Work Order ID 102628

Item ID: D206-642-541

Item Name: Replacement Skidtube

| D3274 | | SKIDTUBE ASSEMBLY | | DART AEROSPACE USA, INC. | | D3274-D-1 | | SHEET 1 OF 1 | | N'S | |

DETAIL F: END FINISHING DETAIL

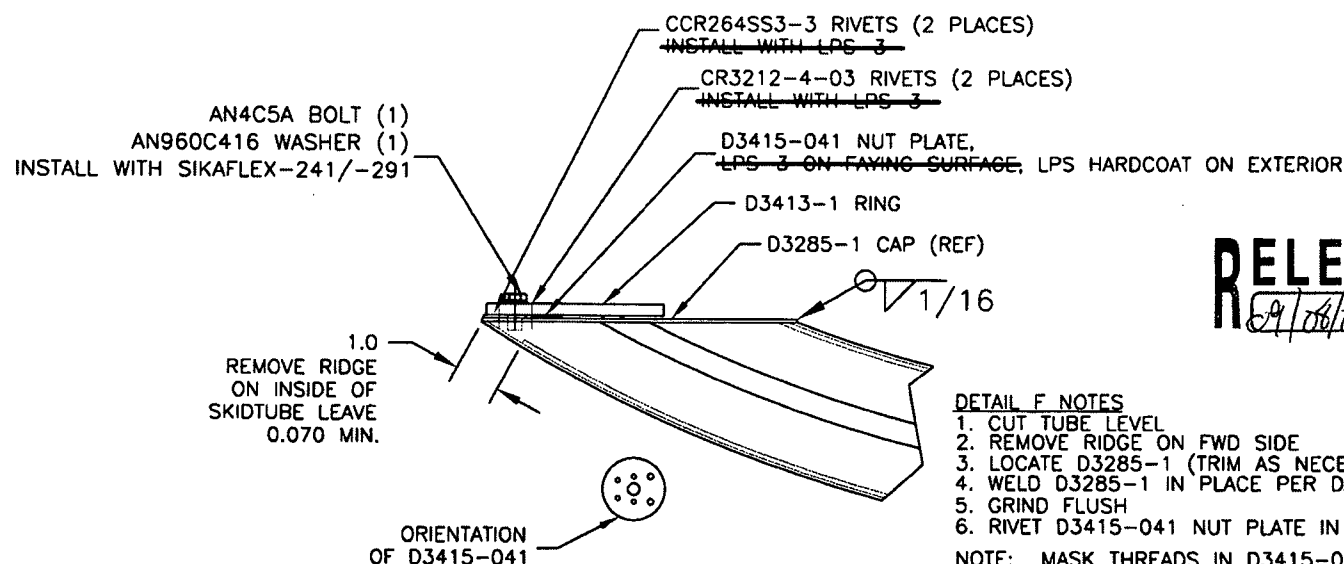
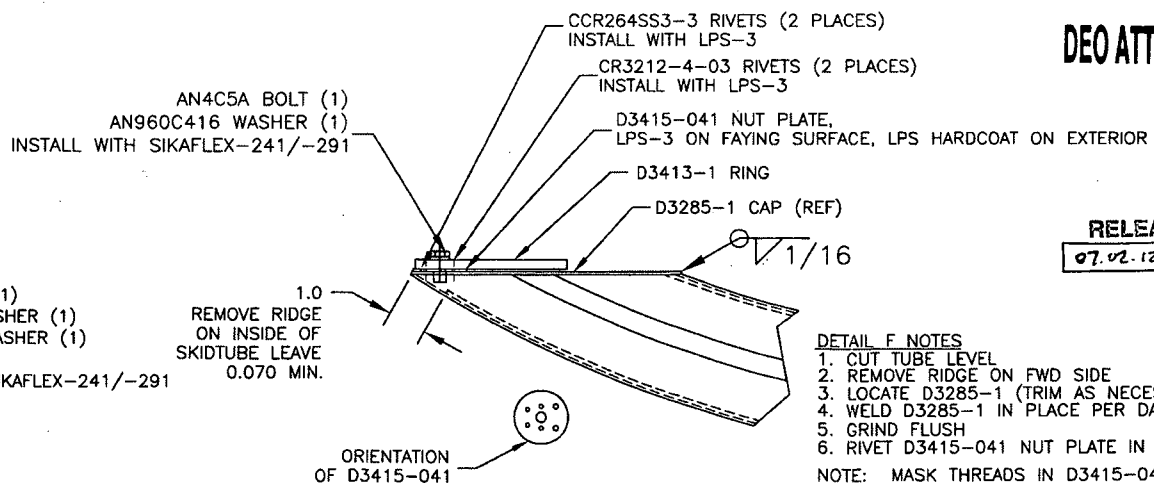
AMEND DETAIL F AS SHOWN:

1. CUT TUBE LEVEL
2. REMOVE RIDGE ON FWD SIDE
3. LOCATE D3285-1 (TRIM AS NECESSARY)
4. WELD D3285-1 IN PLACE PER DART QSI 004
5. GRIND FLUSH
6. RIVET D3415-041 NUT PLATE IN PLACE
